GOVERNMENT OF THE DISTRICT OF COLUMBIA
DEPARTMENT OF TRANSPORTATION

MEMORANDUM

SUBJECT: Zoning Commission Case No. 15-20 – Sursum Corda

Figure 1 Proposed ROW Changes

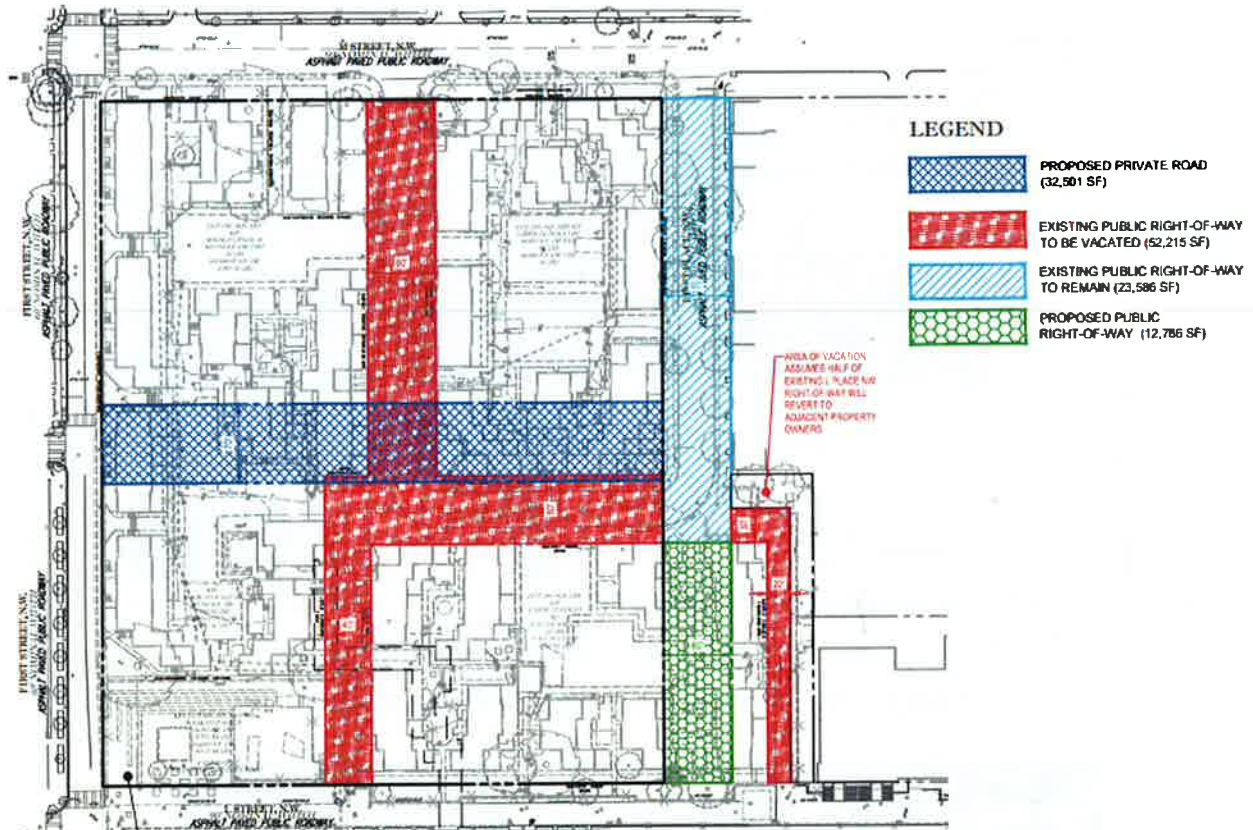
The project includes substantial changes to the internal and external road network. Changes include the closure of existing alleys, 1st Terrace through the site and a portion of 1st Place, the opening of a new segment of 1st Place to align with the existing northern alignment of the street, and the addition of a new segment of Pierce Street as a private street. Changes are shown in Figure 1.

The 1st Place opening is proposed to be 60-feet. While this dimension does not meet DDOT's 75-foot standard for new right-of-way widths, the proposed width of the new 1st Street segment matches the existing width of 1st Street and is therefore appropriate.

Pierce Street, which currently exists west of 1st Street and east of North Capitol Street, is proposed to be opened as a 70-foot wide private street and will align with the public segment of Pierce Street to the west. The existing buildings to the east of the subject site do not permit the connection of Pierce Street to the east. Pierce Street is proposed to have one lane of vehicle travel in each direction and parking on both sides of the street. While private, Pierce Street must be designed and constructed to current DDOT standards. Of note, as Pierce Street is proposed as a private street, the District will not be responsible for street maintenance, snow removal, parking enforcement, and other services the District provides to public streets. Pierce Street will be constructed as part of Phase 1.

Figure 2 – Phase 1 Site Design and Access (Source: Boggs & Partners)

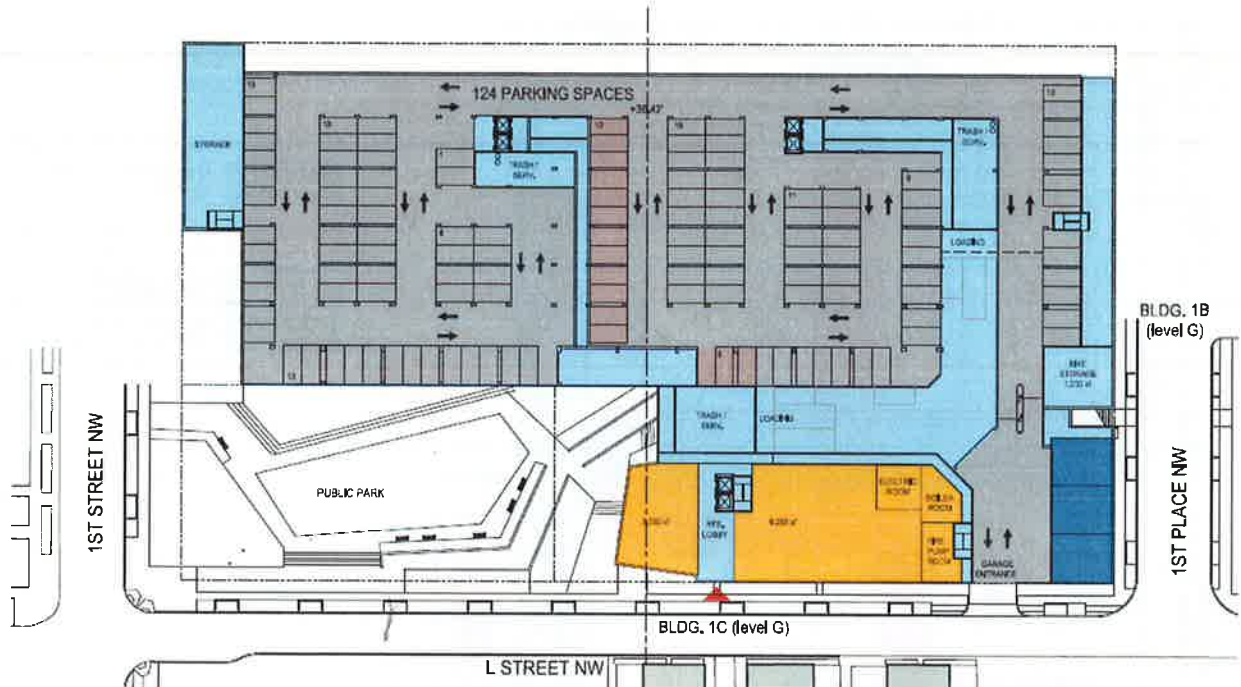
- Phase 1 features two curb cuts – one on 1st Place for vehicular access and one on L Street for combined vehicular, loading access, bicycle, and trash access both of which are consistent with DDOT standards;

The overall ground floor site plan for the project is shown in Figures 2 and 3. Phase 1 features two curb cuts – one on 1st Place for vehicular access and one on L Street for combined vehicular, loading access, bicycle, and trash access. The loading and trash facilities are designed such that they can be accessed with head-in/head-out movements from L Street consistent with DDOT standards. Phase 2 features four curb cuts – one on 1st Place for vehicular access and three on the private Pierce Street for loading and vehicular access. The two loading curb cuts are proposed to require back-in/front-out operations across the sidewalk on Pierce Street. Although Pierce Street is a private street and therefore not subject to DDOT standards that prohibit backing movements through public space, DDOT’s preference would to provide loading access with head-in/head-out movements.

For Phase 1, the loading access from L Street provides access to two loading areas – one for Buildings 1A and 1C that features two 30-foot loading berths and two 20-foot service delivery spaces and one for Building 1B that features one 30-foot loading berth and one 20-foot service delivery space. The loading facilities are connected via access corridors to each building. For Phase 2, the two loading areas accessed from Pierce Street will each contain one 30-foot loading berth and one 20-foot service delivery space.

Figure 3 – Phase 2 Site Design and Access (Source: Boggs & Partners)

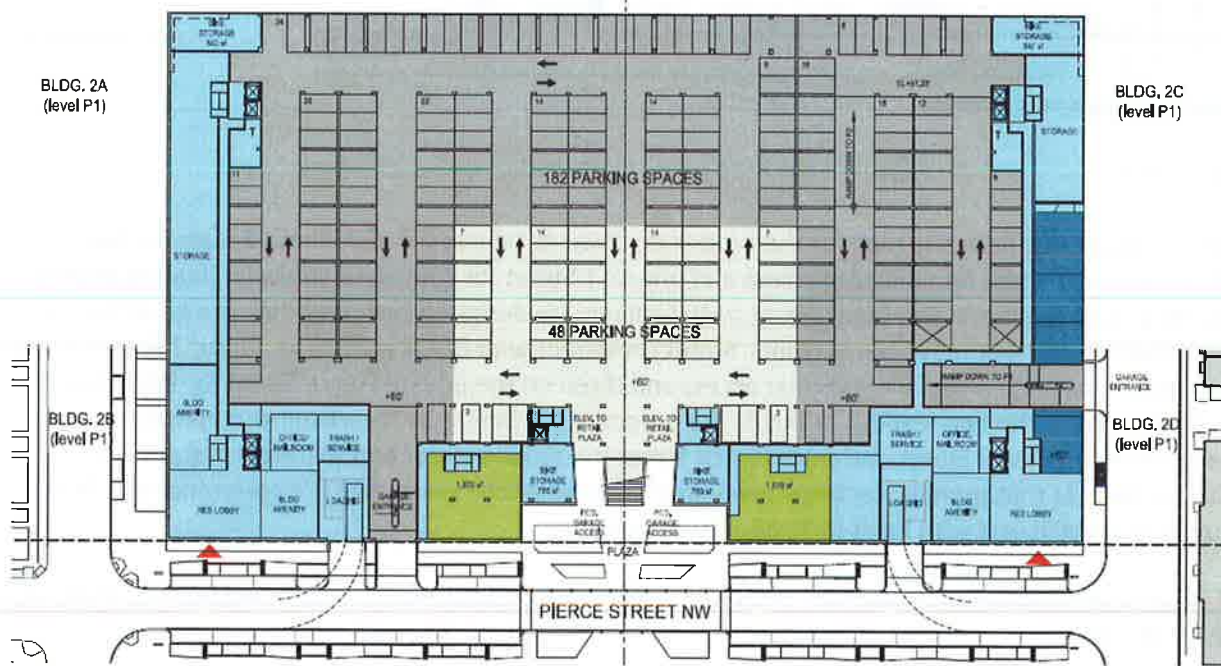
- Phase 2 features four curb cuts – one on 1st Place for vehicular access and three on the private Pierce Street for loading and vehicular access. All three curb cuts proposed on the private Pierce Street are inconsistent with DDOT standards due to either close proximity to each other or back in loading operations; and
